Project Title: Baker Water Treatment Plant Project

Addendum No. 2

BAKER WATER TREATMENT PLANT PROJECT

Environmental Impact Report
(State Clearinghouse No.2010051055)

IRWD Baker WTP EIR Addendum No. 2 - 211448.01
Figure 1
Baker Water Treatment Plant
Proposed Modifications

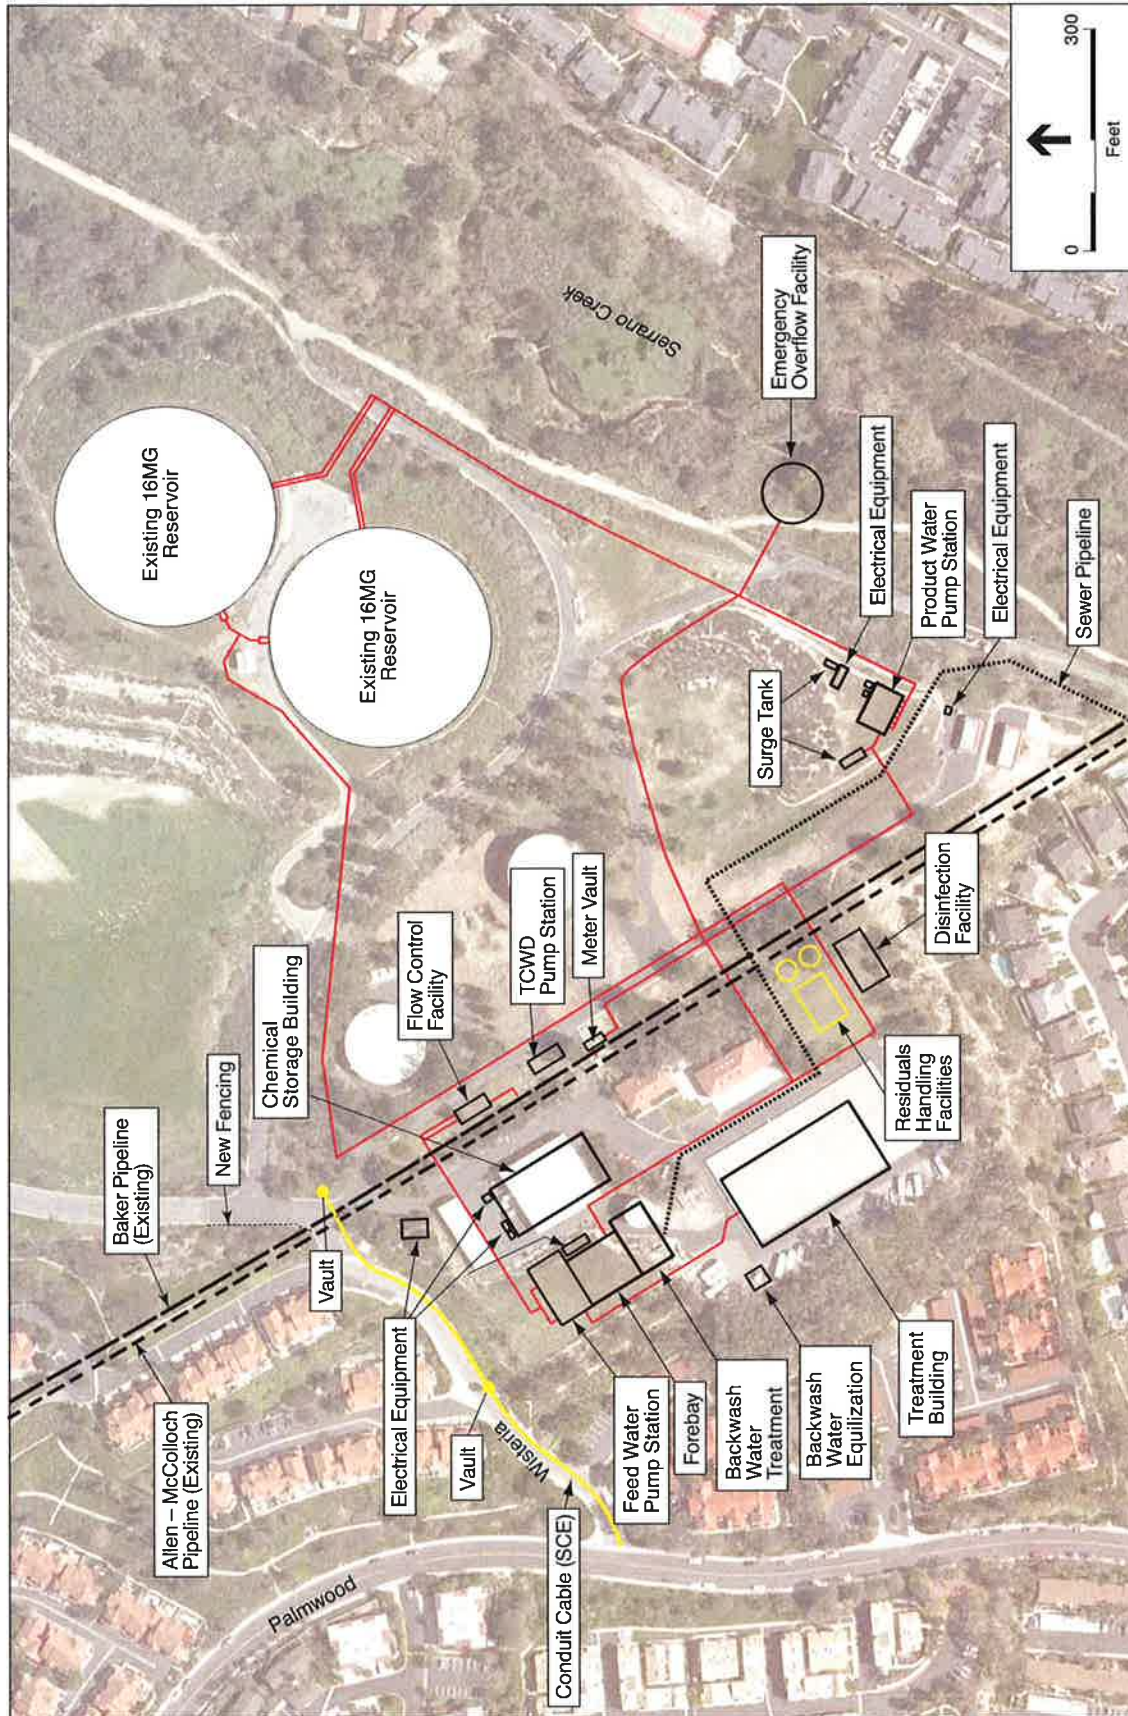
As part of the proposed modification, the waste stream from the treatment process at the Baker WTP would be pumped via a new onsite underground pipeline to proposed residuals handling facilities. The waste stream would be a dilute sludge comprised mostly of silt and inorganic materials. The sludge would be thickened, dewatered, temporarily stored, and hauled offsite to a landfill. The liquid from the dewatering process will be piped to the LAWRP via an existing sewer pipeline connection. The NRW pipeline originally proposed in the Final EIR may not need to be built because the capacity of the existing sewer pipeline is sufficient for dewatering discharges from the proposed residuals handling facilities. However, the NRW pipeline could be constructed in the future.

The following proposed facilities associated with this modification would be built at the Baker site, within the boundaries of the existing BFP as delineated in Figure 2-2 of the Final EIR:

- **Thickeners:** two partially-buried concrete open-air basins, approximately seven feet above ground surface (12-ft water depth) and 22 feet in diameter.

- **Dewatering Building:** one 2,400 square foot (sf) building with a height of approximately 25 feet would contain thickened sludge feed pumps, dewatering centrifuges, a polymer storage and feed system, dewatered sludge conveyor system, and electrical equipment.
- **Load Out:** new facilities adjacent to the dewatering building would facilitate short-term storage and offsite disposal of dewatered sludge.
- **Equalization Storage:** one approximately 25,000-gallon partially buried and enclosed concrete basin would provide equalization for flows entering the sewer pipeline.
- Other ancillary facilities such as new onsite pipelines and up to three pumps or pump stations in subsurface vaults (approximately 10 to 20 HP each).

In addition to the proposed residuals handling facilities, IRWD has determined that the required size of the emergency overflow pipeline would need to be modified up to 54 inches, instead of 42 inches as previously described on pages 2-8 and 2-12 of the Final EIR. The estimated flow rate of 54 cubic feet per second (cfs) from the discharge structure would remain unchanged.

The energy required to operate the Baker WTP would still be approximately 24.5 million kilowatt hours per year (Final EIR, page 2-16) even with implementation of the proposed modification. However, the existing underground power service provided by SCE would need to be upgraded to provide adequate capacity to feed the loads at the new dewatering building. New underground conduit and wiring would be required. As shown in Figure 1, two new vaults would be installed, one on IRWD property near the Baker site entrance off of Wisteria, and one along Wisteria within the right-of-way (ROW). IRWD would install two 6-inch conduits along Wisteria within the ROW, connecting the two vaults and continuing on to existing SCE facilities at the intersection of Wisteria and Palmwood. SCE would install the cable wiring within the conduits, connecting the Baker site to the existing electrical switch at Wisteria and Palmwood. The total length of conduit and cable wiring would be approximately 650 feet.
